# Work Order ID 89859

Item Name: Crosstube Turning Detail

<b>DART AEROSPACE LTD</b>	<b>Work Order:</b> 89859
<b>Description:</b> Crosstube Assembly (205/212/412 Low Fwd)	<b>Part Number:</b> D212-664-147
<b>Inspection Dwg:</b> D212-664-147 <b>Rev:</b> B	<b>Page 1 of 2</b>

DRAWING NO. D212-664-147	TITLE CROSSTUBE ASS'Y (205 LOW FWD)	REV. B	<b>DART AEROSPACE LTD ENGINEERING ORDER</b>		D.E.O. NO. D212-664-147-B-1	SHEET NO. SHEET 1 OF 1	SCALE NTS
DRAWN <i>q</i>	CHECKED <i>ASS</i>	MFG. APPR. <i>VB</i>	APPROVED <i>MP</i>		DE APPR. <i>MP</i>		
DATE 11.07.15	DATE 11.07.20	DATE 11.07.21	DATE 11/07/21		DATE 11.07.21

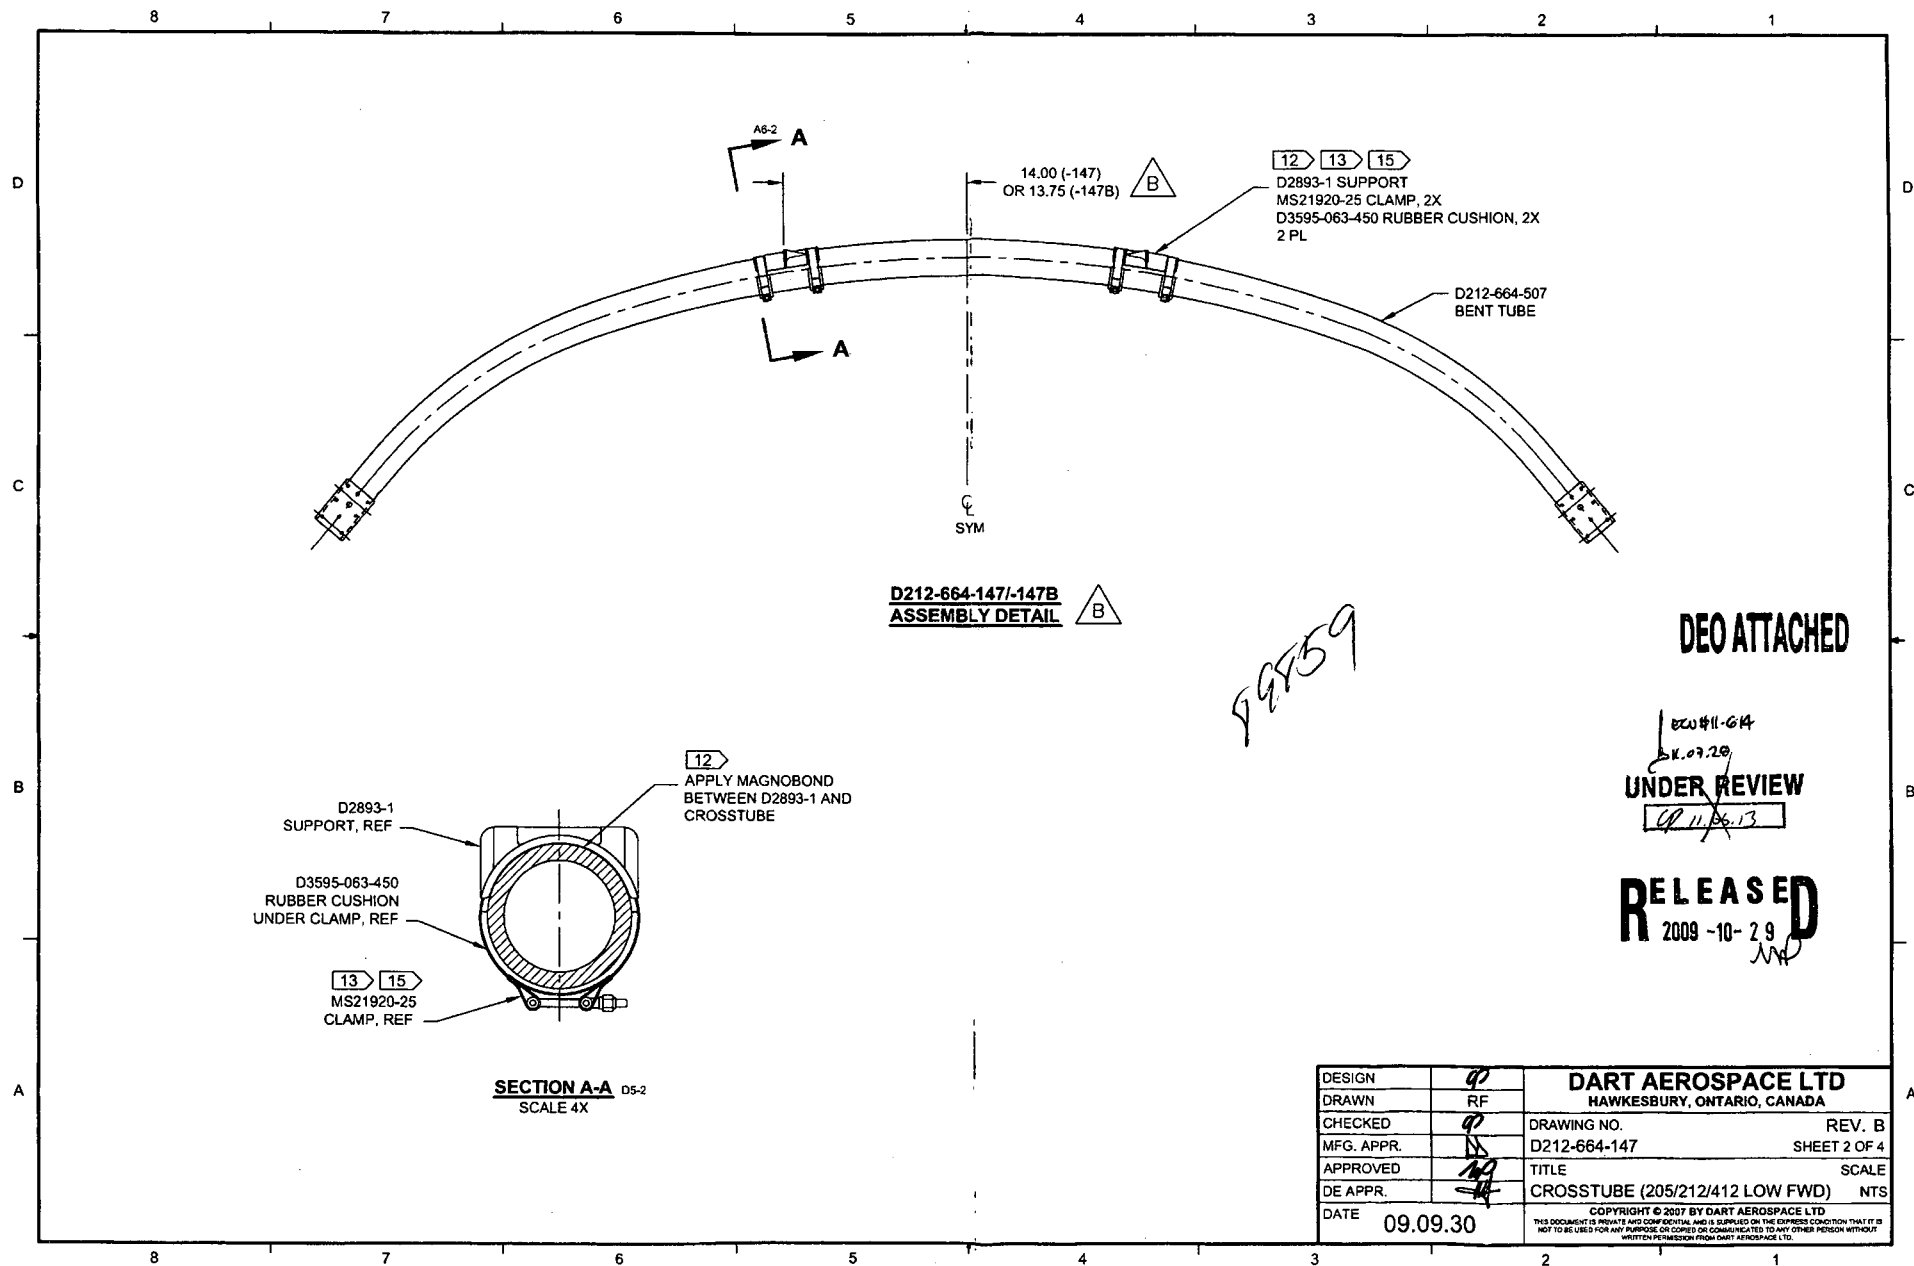
**PURPOSE:**

REPLACE MAGNOBOND WITH PROSEAL.

NOTE 12 & 15, SHEET 1 IS AMENDED AS FOLLOWS:

IS:

12) TO INSTALL D2893-1 SUPPORT: ABRASE MATING SURFACE OF SUPPORT AND CROSSTUBE WITH 180-GRIT SANDPAPER AND REMOVE RESIDUE WITH MEK (OR EQUIVALENT). APPLY A 0.04" TO 0.07" THICK LAYER OF PROSEAL 890 CLASS B-2 (OR AMS-S-8802 CLASS B-2) SEALANT TO MATING SURFACE OF SUPPORT.

15) TORQUE CLAMPS 80 TO 100 IN-LB. ENSURE AT LEAST 1.5 THREADS SHOWING IN SAFETY AND THAT NUT HAS NOT BOTTOMED-OUT AFTER TORQUING. PRIOR TO PACKAGING, RE-CHECK TORQUE ON CLAMPS AFTER PROSEAL 890 SEALANT HAS CURED FOR 72 HOURS.
